Access Compliance Report

Public Rights-of-Way

Intersection ID: 10025384	Main Street: E_9TH_ST	Cross Street: N/A	Location: SW
ADA ID: BF95A1E13B3B	Ramp Type: BlendTrans1	Initial Pass/Fail: Pass	Overall Compliance: No
		Severity Score: 0

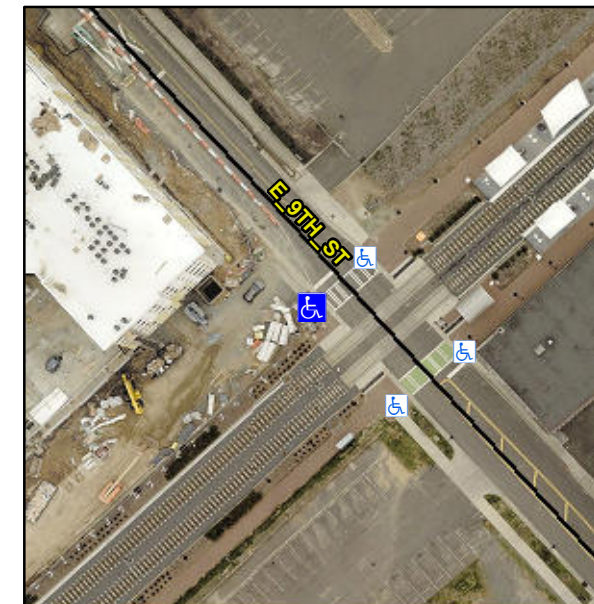
Compliance	Description	Data	Compliance	Description	Data
N/A	Ramp Length (in)	78.0	Yes	BlendTrans Slope (%)	0.9
Yes	Ramp Width (in)	96.0	Yes	BlendTrans XSlope (%)	0.8
N/A	Flare Type LT	None	N/A	Flare Type RT	None
N/A	Flare Slope LT (%)	N/A	N/A	Flare Slope RT (%)	N/A
N/A	Flare Traversable LT?	N/A	N/A	Flare Traversable RT?	N/A
Yes	Landing Length (in)	109.0	Yes	DWS Provided?	Yes
Yes	Landing Width (in)	96.0	Yes	DWS Contrast?	Yes
Yes	Landing Slope (%)	1.6	Yes	DWS Length (in)	24.0
Yes	Landing X Slope (%)	1.1	Yes	DWS Full Width?	Yes
N/A	Landing Curb? (Y/N)	No	Yes	DWS Offset (in)	0.0
N/A	Shared Landing?	Yes			
Yes	Gutter Ponding?	No	Yes	Gutter Slope (%)	0.7
Yes	Gutter Lip Ht (in)	0.0	Yes	Gutter X Slope (%)	1.2
N/A	Painted X Walk1?	No	N/A	Painted X Walk2?	N/A
	X Walk 1 Direction	To NE		X Walk 2 Direction	N/A
	X Walk 1 Width (in)	N/A		X Walk 2 Width (in)	N/A
	X Walk 1 Slope (%)	1.6		X Walk 2 Slope (%)	N/A
	X Walk 1 X Slope (%)	1.2		X Walk 2 X Slope (%)	N/A

N/A	Ramp inside XWalk1?	N/A	N/A	Ramp inside XWalk2?	N/A
	Road Slope (%)	1.2		Clear Space?	Yes
	Road X Slope (%)	1.6	N/A	Clear Space to XWalk (in)	N/A
Yes	Any Obstructions?	No	Yes	Storm Grate/Utility Hazard?	No
	Obstruction Type			Storm Grate/Utility Type	
		N/A			N/A
			Yes	Surface Condition? (G/P)	Good
			No	Curb Slope (%)	11.9

Remove & Replace Curb Slope and Extend Ramp.
